# Authorized Field Change

AFC 14903

**Subject:** Exhaust Ground Clearance Correction.

Model: DuraStar®

**Figure 2. Diffuser Hanger Bracket.**

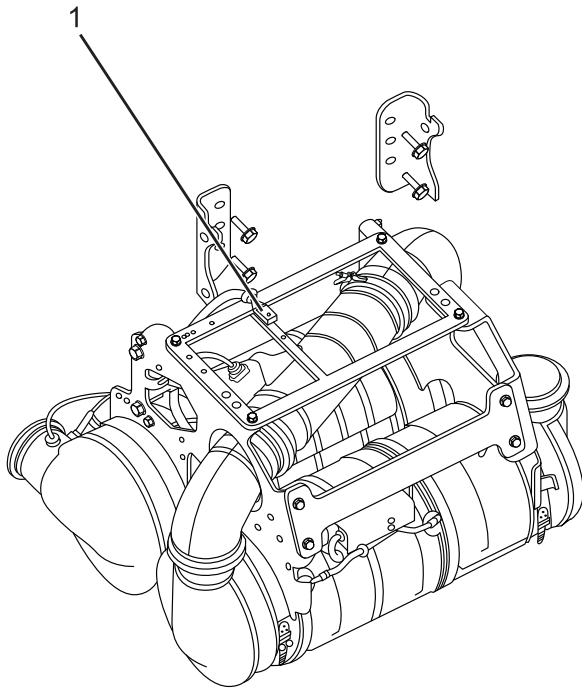
8. Remove two bolts (Figure 2, Items 1 and 2), tailpipe (as a unit) (Figure 2, Item 4), and diffuser hanger bracket (Figure 2, Item 3) from vehicle. Discard diffuser hanger bracket.

26. Using torque wrench, tighten V-clamp (Figure 1, Item 4) to 106 lb-in (12 N•m).
27. Install tailpipe (Figure 2, Item 4) as a unit and new diffuser hanger bracket (Figure 2, Item 3) on frame rail with bolts (Figure 2, Items 1 and 2) hand tight.

**Figure 6. Frame Rail Brackets.**

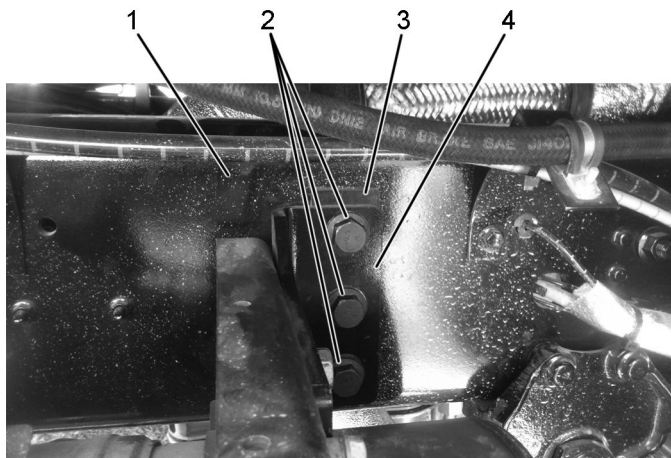
16. Remove six bolts, nuts (Figure 6, Item 2), and two brackets (Figure 6, Item 1) from frame rail. Discard two brackets.
17. Install two new aftertreatment assembly mounting brackets (Figure 5, Item 1) onto SCR canister with four bolts (Figure 5, Item 2) hand tight.

**Figure 7. Spacer Installation.**

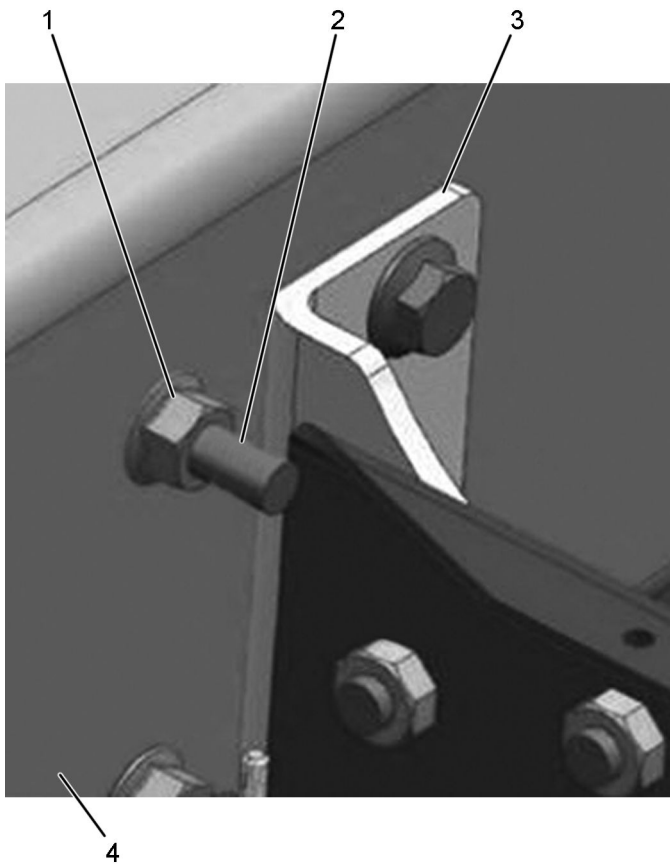
18. Raise DPF / DOC and SCR canister into position and install two new spacers (Figure 7, Item 3) between two brackets (Figure 7, Item 4) and frame rail (Figure 7, Item 1) with six bolts and six nuts (Figure 7, Item 2) into frame rail, hand tight.

23. Using torque wrench, tighten six bolts (Figure 7, Item 2) to 192 lb-ft (260 N•m).
24. Using torque wrench, tighten four aftertreatment assembly mounting bracket bolts (Figure 5, Item 2) to 192 lb-ft (260 N•m).

**Figure 8. Rear-Most Bolt.**

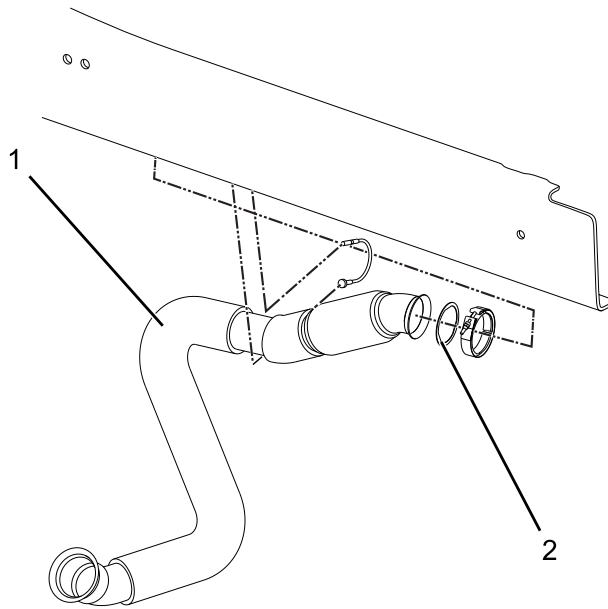
**NOTE: To provide adequate clearance, install bolt with head on outside of frame rail.**

19. Remove nut (Figure 8, Item 1) and bolt (Figure 8, Item 2) from frame rail (Figure 8, Item 4), next to rear-most mounting bracket (Figure 8, Item 3).
20. Install bolt (Figure 8, Item 2) and nut (Figure 8, Item 1) into frame rail (Figure 8, Item 4) with bolt head on outside of frame rail.

**Figure 9. Turbocharger Down Pipe.**

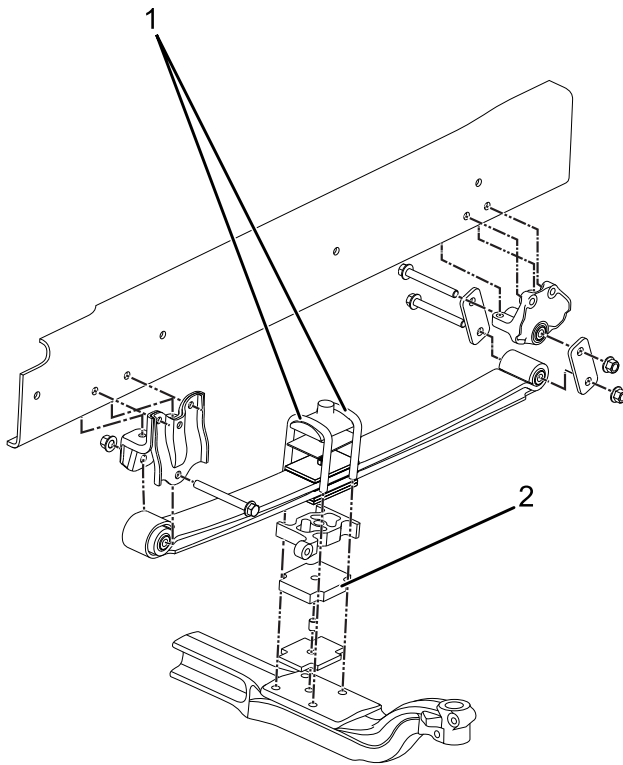
21. Remove turbocharger down pipe (Figure 9, Item 1) and gasket (Figure 9, Item 2) from vehicle. Discard turbocharger down pipe and gasket.
22. Install new gasket (Figure 9, Item 2) and new turbocharger down pipe (Figure 9, Item 1) onto turbocharger and SCR canister with V-clamp hand tight.

25. Verify that turbocharger down pipe bellows section is parallel to frame and no visual bends are present. While securing cable, use a pair of vice grips or pliers to hold crimped end before threads to prevent cable twist.

**Figure 10. U-Bolts.**

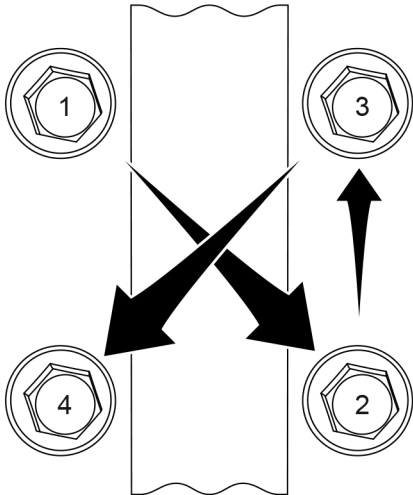
40. Remove four nuts and two U-bolts (Figure 10, Item 1) from axle and allow axle to rest on floor jack. Discard nuts and U-bolts.
41. Remove 1/2-inch spacer (Figure 10, Item 2) from underneath shock mount. Retain spacer as this part will be used on right side of vehicle.
42. Install new 1-inch spacer (Figure 10, Item 2) underneath shock mount.
43. Install two new U-bolts on axle with four new bolts (Figure 10, Item 1) hand tight.
44. Remove front tire on right side. Refer to [Service Manual Section, Wheels, Rims, and Tires, S17001Y](#).
45. Place a floor jack under front axle and raise floor jack until it just contacts axle. **DO NOT put a load on the springs.**
46. Remove four nuts and two U-bolts (Figure 10, Item 1) from axle and allow axle to rest on floor jack. Discard nuts and U-bolts.
47. Install 1/2-inch spacer (Figure 10, Item 2), removed from left side, underneath shock mount.

48. Install two new U-bolts on axle with four new bolts (Figure 10, Item 1) hand tight.
49. Verify 1-inch spacer (Figure 10, Item 2) is on left side and 1/2-inch spacer is on right side.
